Staff Report

To: Coalville City Council and Mayor
From: Don Sargent, Community Development Director
Date of Meeting: March 25, 2024
Re: Rivers Edge/Wilde Property MPD – Preliminary Plan
Action: Review and Discussion - Work Session

River's Edge/Wilde Property MPD Preliminary Plans

DATE: March 13, 2024 (Updated from 9/14/23 and 12/19/23)
TO: Coalville City Planning Commission
CC: Don Sargent, Sheldon Smith, Kyle Clark, RaeShel Hortin
FROM: Chris Thomsen
SUBJECT: Wilde Property Apartments Development Review

PRELIMINARY
WILDE PROPERTY APARTMENTS
SITE PLAN
FOR: COURTNEY RICHINS
330 SOUTH MAIN ST
COALVILLE, UTAH
PROJECT #19-018

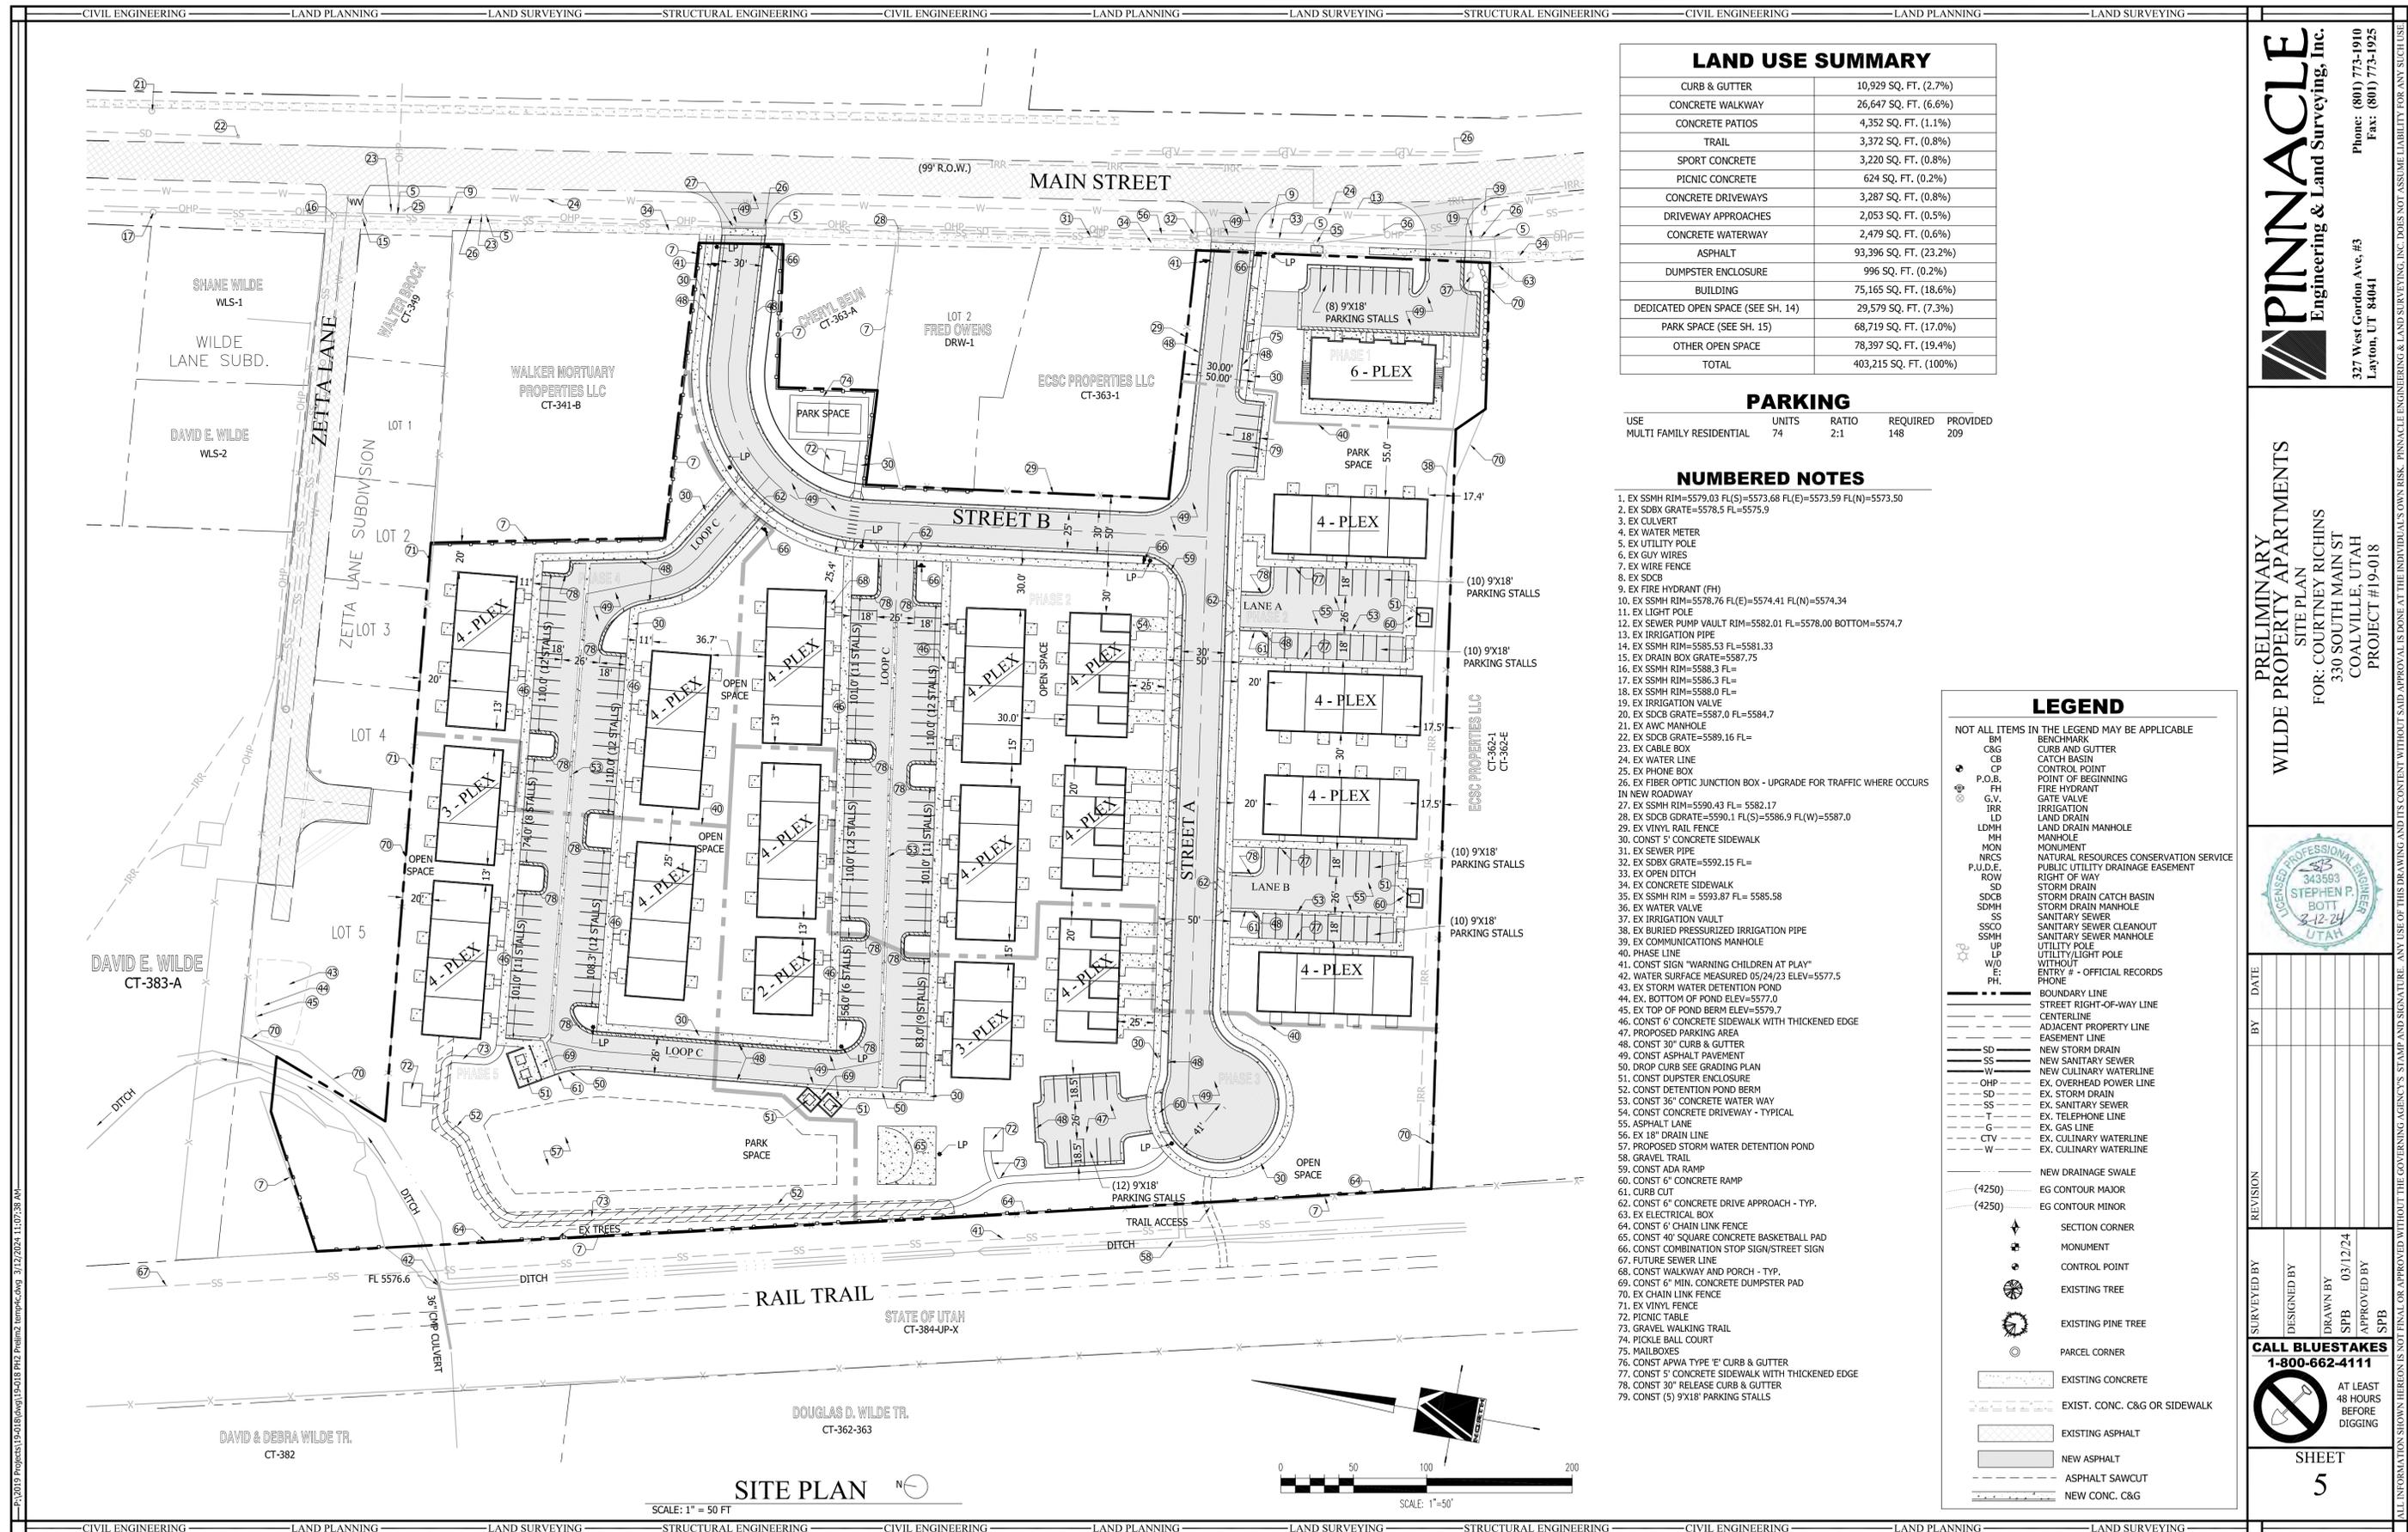
- 1) *Add easements or PUE to Plat for all city infrastructure.*
- 2) *Complete. Add 10' PUE around Lot 1 and 2 on plat*
- 3) *Complete. On Sheets 8 thru add water info.*

- 4) *Update drawings to show minimum storm drain pipe size 15 inch.*
- 5) *Complete. Sheet 5 road labels do not match sheet 6*
- 6) *Complete. Label fire hydrant end of Street A on Sheet 6*

- 7) *Complete. Call out water valves on Sheet 6*
- 8) *Complete. Call out stop signs on Sheet 6*
- 9) *Complete. Call out Children at plan signs on Sheet 6*

- 10) *Complete. Call out street name signs on Sheet 6*
- 11) *On Sheets 5 and 6 verify that labels match call outs.*
 - a) *Call out all waterline bends and call out what angle the bends are*

- b) *Label 87 in near the intersection of Street A and Street B should be 67*
 - c) *Label 40 West of 6-plex appears to be wrong label*
 - d) *Label 59 near parking lot on the end of Street A need to be moved to the end of storm drain line.*

- e) *Label all of the dumpster enclosers add enclosure for 6-plex*
- 12) *On Sheets 5 and 6 remove labels from subdivision to the North*
- 13) *Provide storm drain inlets at each entrance.*

| SHEET | COMMENTS |
|-------------|--|
| 5 | All park space area uses to be identified and shown on plan |
